RE: Enterprise Recycling and Disposal Facility
Cell 16 Construction Completion Report
Response to 10/30/18 RAI
Permit No.: 177982-023-SC/T3, Pasco County
WACS No.: 87895

RE: Enterprise Recycling and Disposal Facility
Cell 16 Construction Completion Report
Revised Report per 10/30/18 FDEP Comments
Angelo's Aggregate Materials, Ltd.
FDEP Permit Nos. 177982-023-SC/T3
WACS No.: 87895
Pasco County, Florida

C:\Civil 3D Projects\02000-144-14-02\CADD\Misc\ARNOLD-CELL 16\AB-03.dwg PLOT DATE 11/7/2018 1:25 PM BY MAF

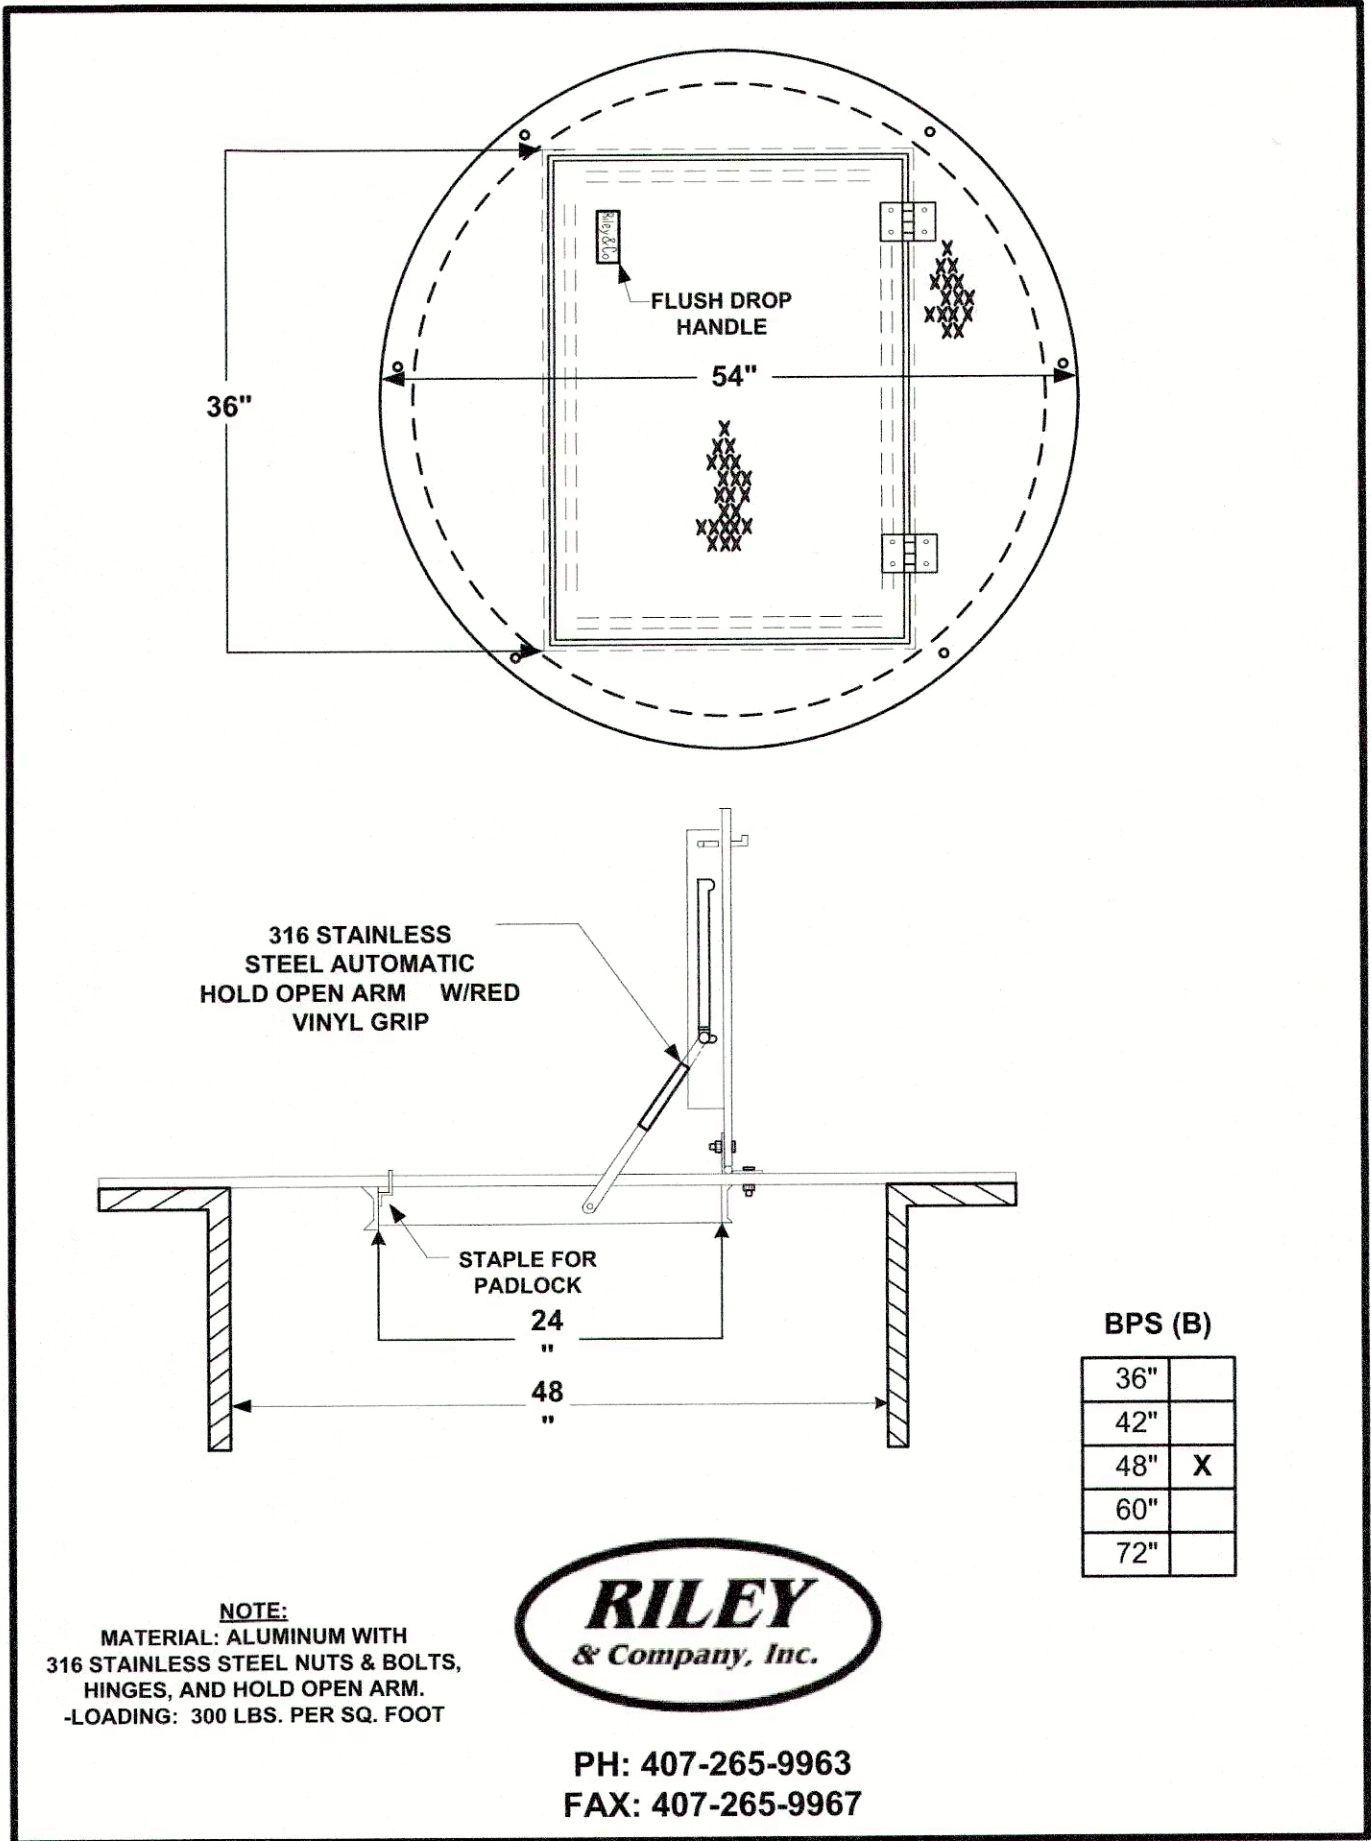
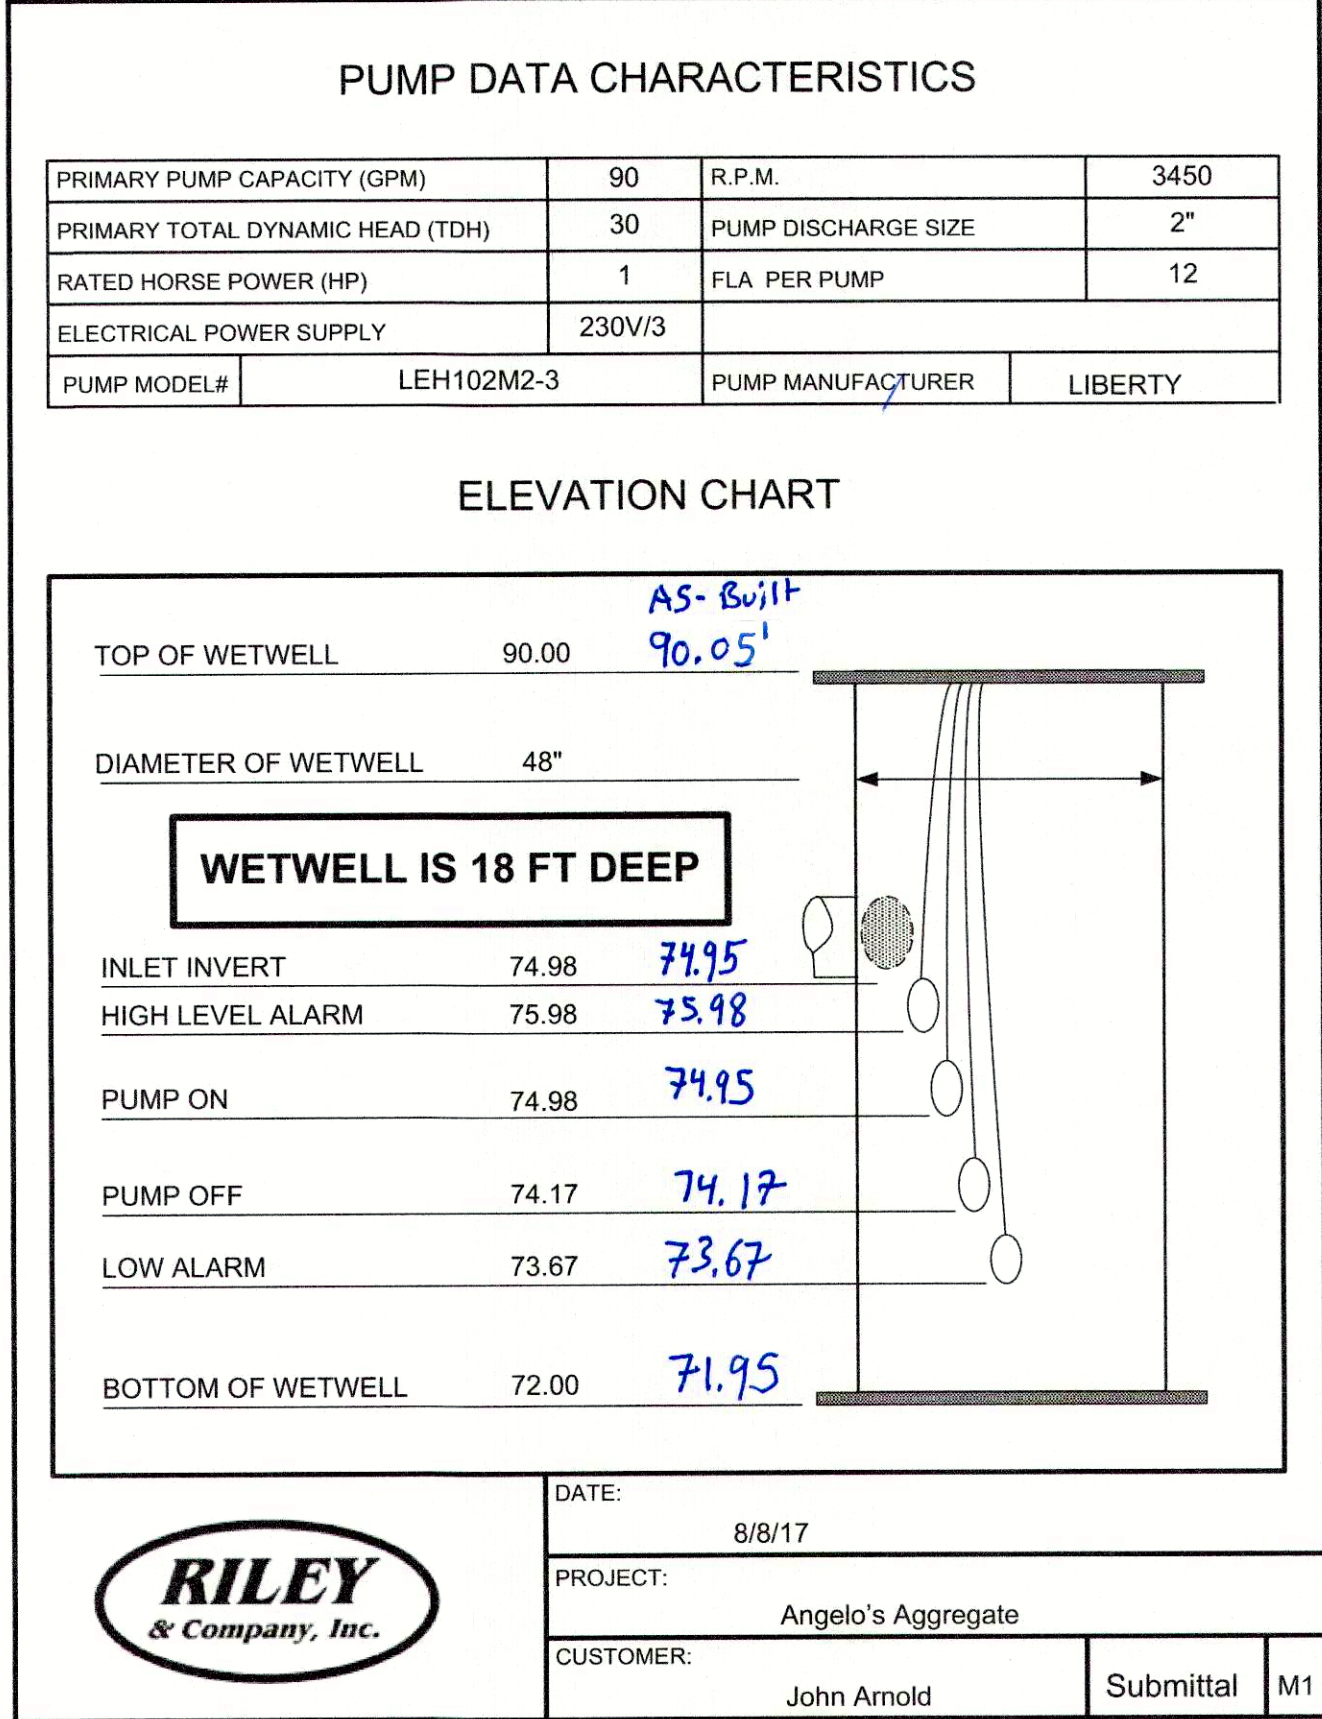
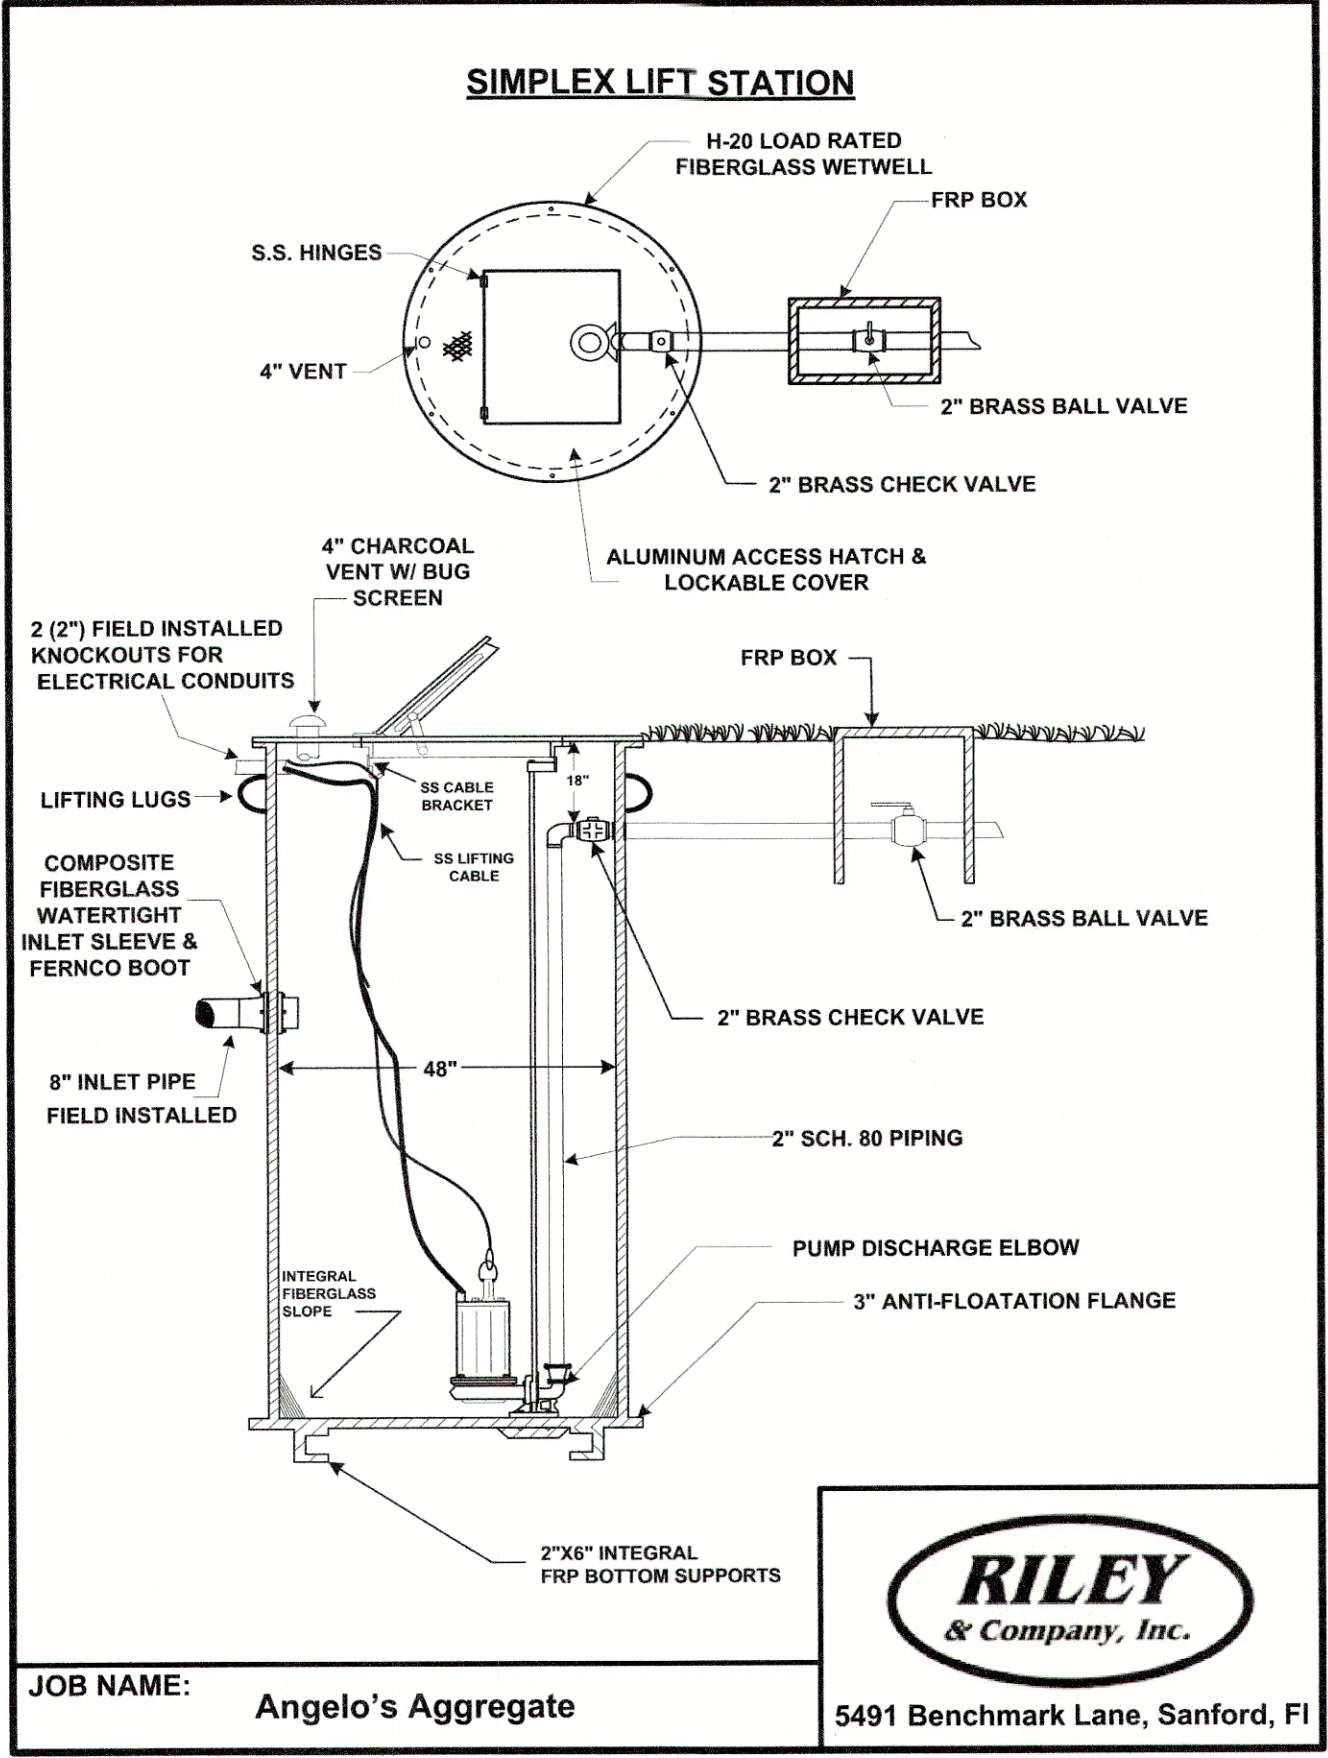
- a. The record drawing provided in Attachment B did not include as-built drawings of the constructed leachate collection trench and piping system and the constructed wet well, pump, and float control system. Please verify and provide as-built drawings of these systems.

d. The easternmost top of clay elevation in the leachate trench reported on the "Top of Clay" as-built drawing in Appendix B is 74.90 ft. NGVD. The as-built invert elevation of the leachate collection pipe at the wet well [STM-1] is reported as 74.95 ft. NGVD. Based on the apparent installation of the leachate collection pipe directly on top of the installed clay layer in the leachate trench described in Comment #5.b. and shown on the photo above, it appears that gravity flow in that section of the solid leachate pipe will flow away from the wet well. Please verify this apparent construction deviation and based on the information provided on the asbuilt drawings for the leachate collection trench and piping system provided in response to Comment 5.a. above, provide supporting justification why the leachate collection system will function properly under these conditions.

RESPONSE: Drawing C4.00 of the plan set has been included in Attachment B to show the as-built conditions of those systems.

RESPONSE: The difference between the two reported elevations is .05' or approximately ½" and is not expected to have any measurable influence on the leachate conveyance system. Using a vertical tolerance of +/- 1/16' (0.063') the elevation at the wetwell could be determined

to be as low as $74.95 - 0.063 = 74.89'$ and other elevation could be determined to be $74.90 + 0.063' = 74.96'$, showing a positive slope towards the wetwell.
